## Q13.1.20 – Green Belt

**The ExA acknowledges the Local Authorities’ objections to the proposed development in the Green Belt. Without prejudice to these objections, the ExA would like to understand from the Local Authorities whether there are any particular locations within the Green Belt where the effects of the Project on openness would be particularly pronounced, and conversely, whether there are locations where effects on openness would be avoided or at the lower end of the harm scale.**

### 1.0 Introduction

HS1 cutting from Scotland Lane land bridge, looking east – Lower Thames Crossing works would project into this cutting, providing space for Darnley Lodge Lane. Bank would be surcharged and supported by a retaining wall in the cutting.

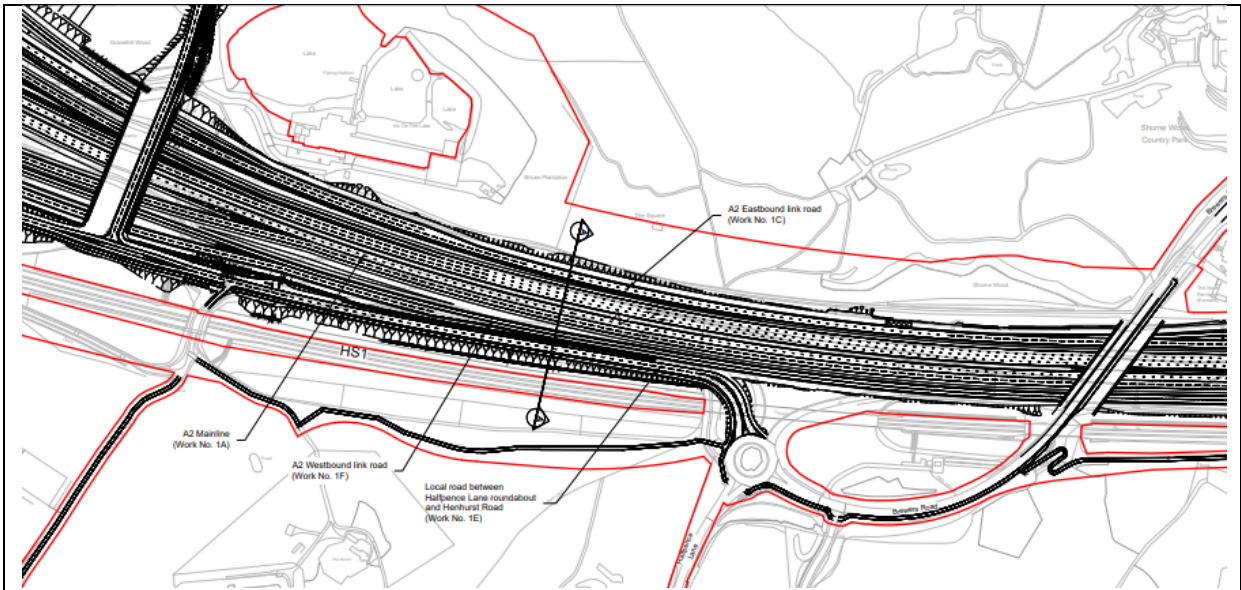
- **HS1 cutting between Halfpence Lane/Brewers Road and Scotland Lane** – more detailed section would be useful to show the relationship of Darnley Lodge Lane with HS1 railway/catenaries etc. There is a need to understand here what Errant Vehicle Protection will be required and area available for landscape mitigation to understand impact of project on visual openness.

CROSS SECTION A-A  
A122 LTC/A2 JUNCTION - 2

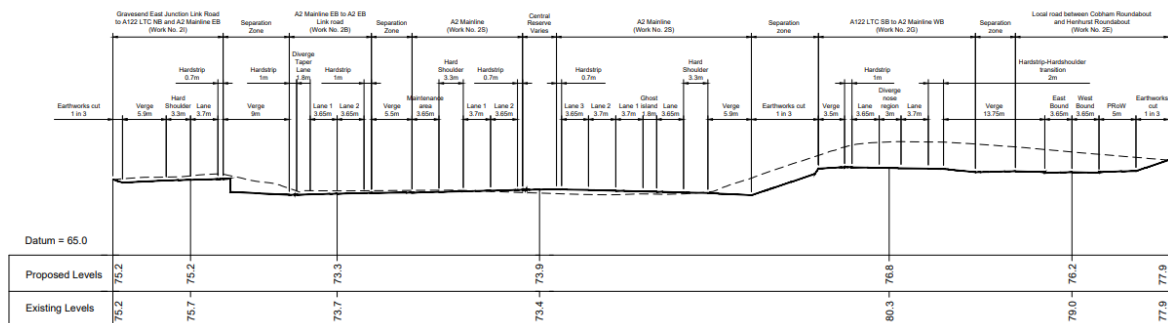
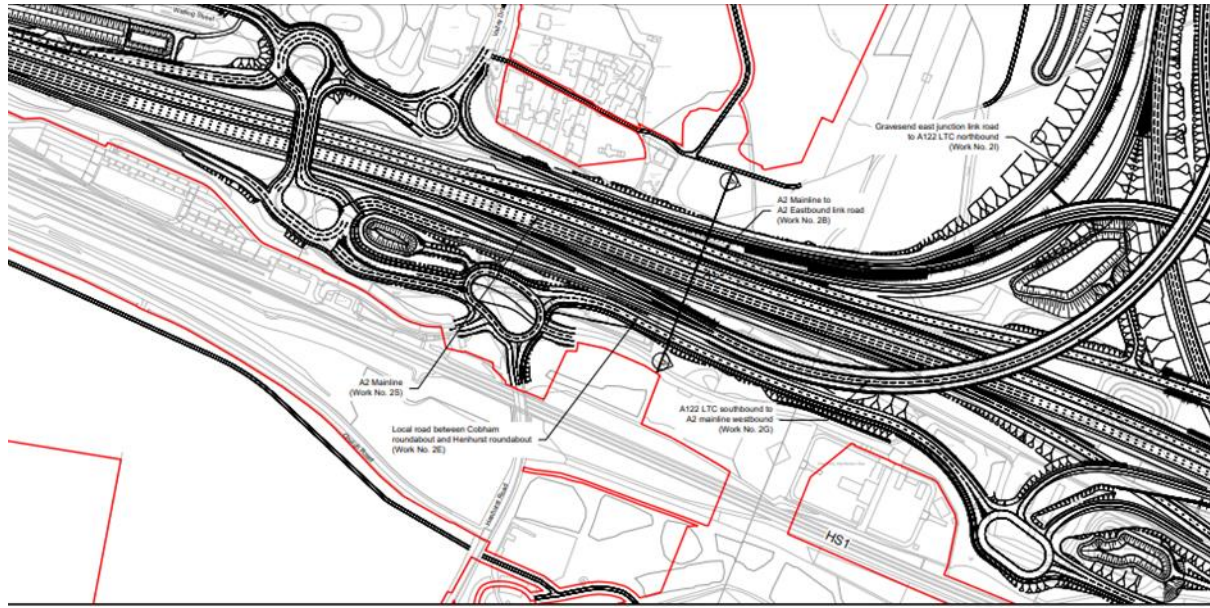
Whilst the applicant has provided further expanded sections of the junction, these are extremely difficult to interpret alongside the plans (REP2-069 and 071). Gravesham considers that the visualisations and photomontages provided in support of the application are also difficult to interpret given the scale of what is proposed. The ExA will also be mindful that the DCO process also seeks to proactively engage with the general public and if the local planning authority is having difficulties, then lay people are likely to find themselves in an even worse position. Gravesham points out that at EIA Scoping, the applicant was asked to produce a digital terrain model of the scheme so that impacts could be better understood but this was not produced. Whilst a 'fly-through' has been produced for year 15 for promotional purposes, it only provides a view from above and is no substitute for an verified

digital model that can be interrogated. Gravesham is particularly concerned regarding the lack of detail regarding the interface of the project with HS1 in this section; the relative levels of HS1 compared to adjoining roads; whether Errant Vehicle Protection will be required and the form this might take; and the effectiveness of proposed landscape mitigation in terms of both Lower Thames Crossing and HS1, having regard to the presence of the Singlewell Feeder Station. It is also a matter of concern that it appears the applicant has yet to resolve with HS1 what the required safety margin is between the Singlewell Feeder Station and the public highway, particularly as we understand that HS1/National Grid had to install a blast wall to the front of the transformers (APP-110). It is noted that HS1 has committed to provide a viaduct over the existing HS1 drainage ponds to the west of the Cobham South Services (Work 2E(i) REP3-077). Whilst these ponds currently receive water from HS1 and the Feeder Station, there is also a culvert under HS1 from the south which would carry water in an extreme rainfall event. The extent of the affected area is shown on the EA surface water flood risk map reproduced below. The surface water drainage arrangements would also have to deal with this, plus an allowance for climate change and be capable of being maintained long-term. This may have implications for the final design, resulting in a reduction in the area available for landscaping, leaving the A2/A122 junction more open to view from HS1 and the south. Gravesham also notes that the Works Plan shows two new sub-stations to be built south of the Cobham roundabout in this location (Works Plan REP2-037 shown as SS4 + SS5 and Work MU13 in the dDCO REP3-077) which appear to conflict with the position of the existing drainage culvert under HS1 (see plan below) The ExA will also note that the LTC works will also significantly reduce landscaping that was put in place to mitigate HS1, leaving this more open to view – including from the A2/A122 junction.

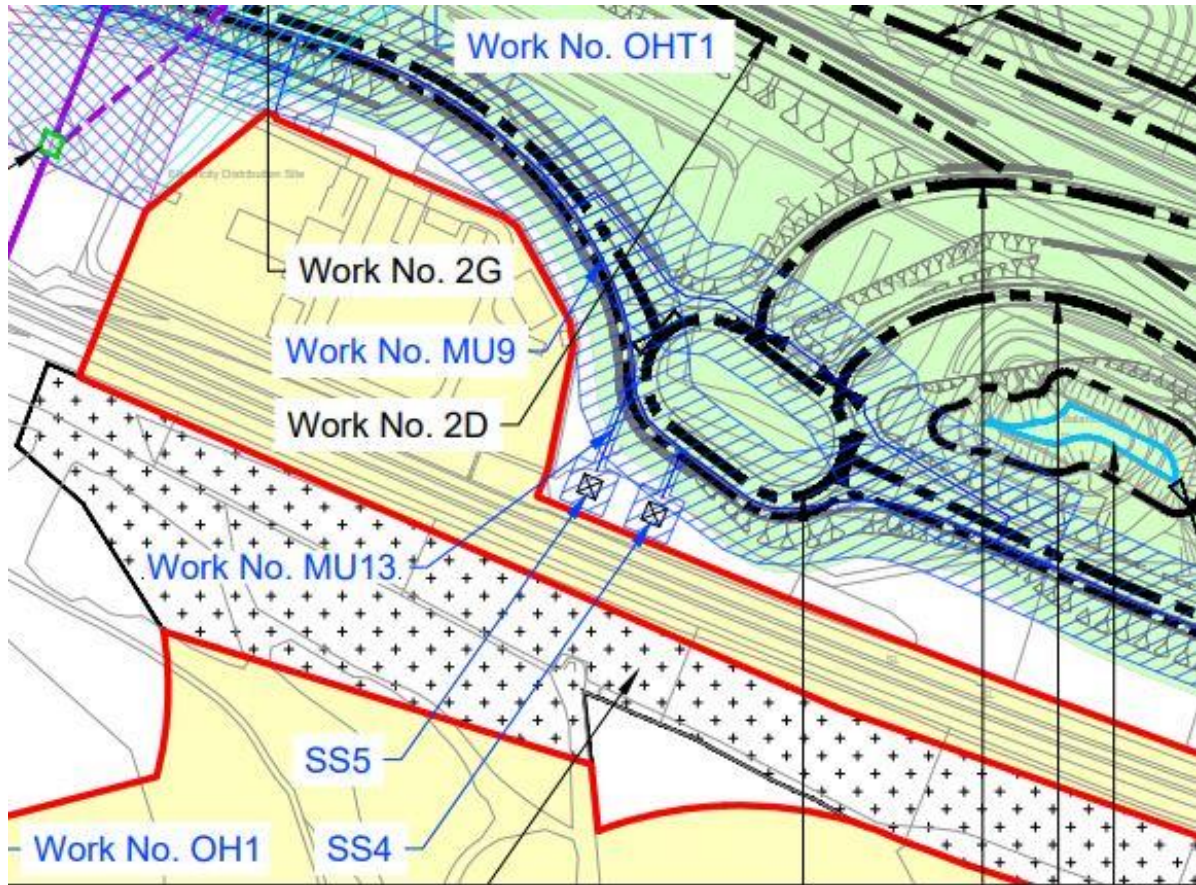
Extract from Works Plan (REP3-037) showing locations of proposed substations south of Cobham roundabout and comprising Work MU13 in the dDCO (REP3-077). Note position of southern end of the culvert under HS1 shown on plan. See also plan of Feeder Station attached. Note that low-loader turning head to serve feeder station to facilitate replacement of transformers (40 year maintenance period) is also lost.
